In response to your letter of July 23, 2018, please find the enclosed progress and transition plans on the Americans with Disabilities Act (ADA) reviews conducted in the DLR Job Services Offices in Huron, Mitchell and Sioux Falls.

RE: One-Stop ADA Reviews

HURON JOB SERVICE

HURON JOB SERVICE PHOTOS

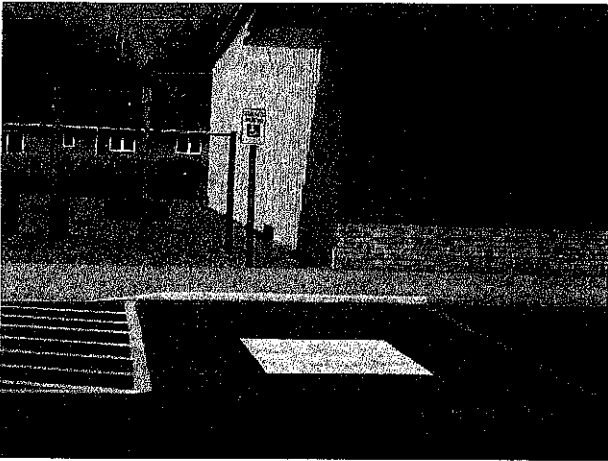
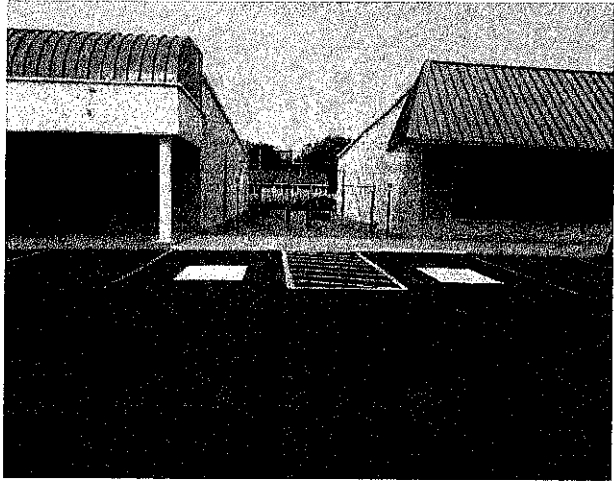
1. **Finding – Low Effort:** The main van accessible parking spot on the south edge of the parking lot is not identified with a ‘Van accessible’ handicap parking sign.

2. **Finding – Low Effort:** The lobby area light switch at the front of the lobby is blocked by chairs and a brochure display.
Response: Resolved. We have moved the brochure display to the other side of the door so as to not block the light switch. *One picture included.*

Response: Resolved. The landlord removed the handicapped parking spot in front of the office and the one next to the north side of the building located to the south. They then created one parking space that is Van Accessible and the other that is Handicapped both located further to the north between our office and Anytime Fitness. And they created a handicapped parking space in front of Java Hut which is on this same campus, but it is located in front of the building to the south of us. So, they have the required three handicapped parking spaces with one of the three being van accessible. *Four pictures included.*
